Introduction

This contribution addresses several of the editorial comments and questions raised in contribution T1A1.5/92-123.

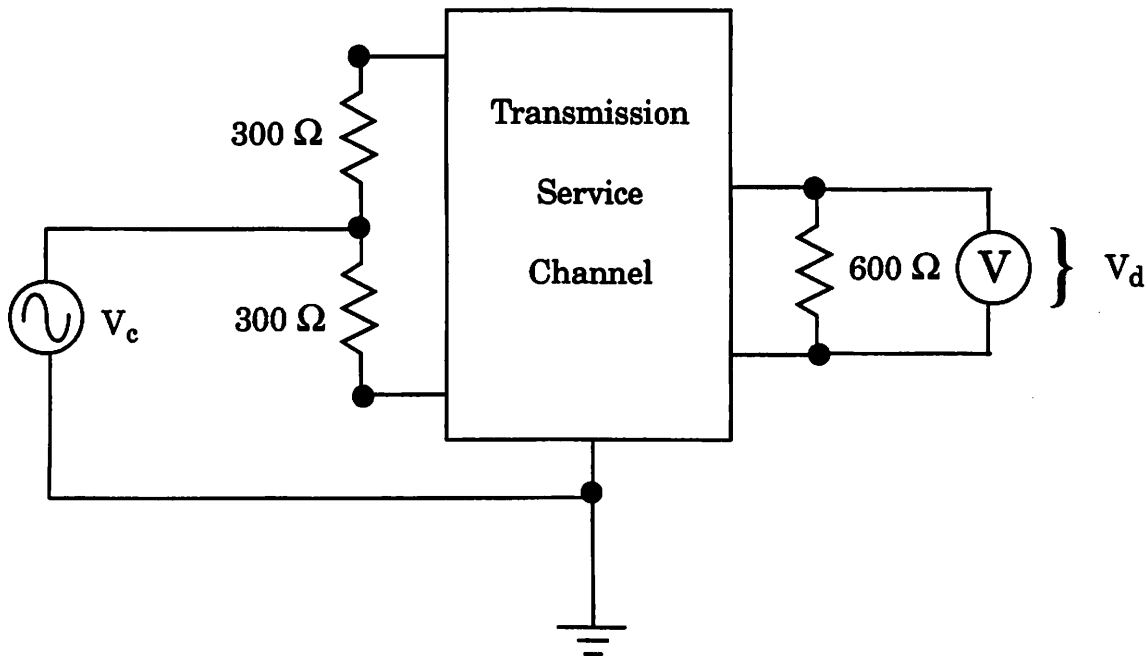
CMRR Technique (page 12, section 4.3.1.1.3): We agree that V_o should be changed to V_d for consistency. A figure that describes the measurement set up is shown below (this figure should be added to the draft standard). As a rough rule of thumb, if the 300Ω resistors are of 1% tolerance, then CMRR's up to 40 dB can be measured. If they are .1%, then 60 dB, if .01%, then 80 dB, etc.
